# Access Compliance Report

## Public Rights-of-Way

Intersection ID: 3070	Main Street: MT_HOLLY-HUNTERSVILLE_RD	Cross Street: WALDEN_RIDGE_DR	Location:	N/A
ADA ID: 366EAEB6EDCB	Ramp Type: Perp	Initial Pass/Fail: Fail	Overall Compliance: No	Severity Score: 25
Codes/Mitigation Info/Possible Solution		Field Measurements/Component Compliance

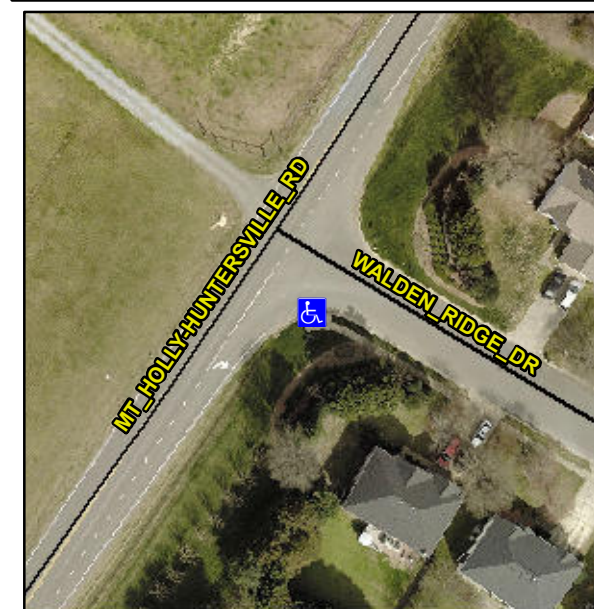
Compliance	Description	Data	Compliance	Description	Data
N/A	Ramp Length (in)	58.0	No	Ramp Slope (%)	12.3
Yes	Ramp Width (in)	48.0	Yes	Ramp XSlope (%)	1.9
N/A	Flare Type LT	N/A	N/A	Flare Type RT	N/A
N/A	Flare Slope LT (%)	N/A	N/A	Flare Slope RT (%)	N/A
N/A	Flare Traversable LT?	N/A	N/A	Flare Traversable RT?	N/A
N/A	Landing Length (in)	N/A	N/A	DWS Provided?	N/A
N/A	Landing Width (in)	N/A	N/A	DWS Contrast?	N/A
N/A	Landing Slope (%)	N/A	N/A	DWS Length (in)	N/A
N/A	Landing X Slope (%)	N/A	N/A	DWS Full Width?	N/A
N/A	Landing Curb? (Y/N)	N/A	N/A	DWS Offset (in)	N/A
N/A	Shared Landing?	N/A			
N/A	Gutter Ponding?	N/A	N/A	Gutter Slope (%)	N/A
N/A	Gutter Lip Ht (in)	N/A	N/A	Gutter X Slope (%)	N/A
N/A	Painted X Walk1?	No	N/A	Painted X Walk2?	N/A
	X Walk 1 Direction	To W		X Walk 2 Direction	N/A
N/A	X Walk 1 Width (in)	N/A	N/A	X Walk 2 Width (in)	N/A
	X Walk 1 Slope (%)	0.9		X Walk 2 Slope (%)	N/A
	X Walk 1 X Slope (%)	4.6		X Walk 2 X Slope (%)	N/A

**Remove & Replace Entire Ramp.**

**R304.2.2**
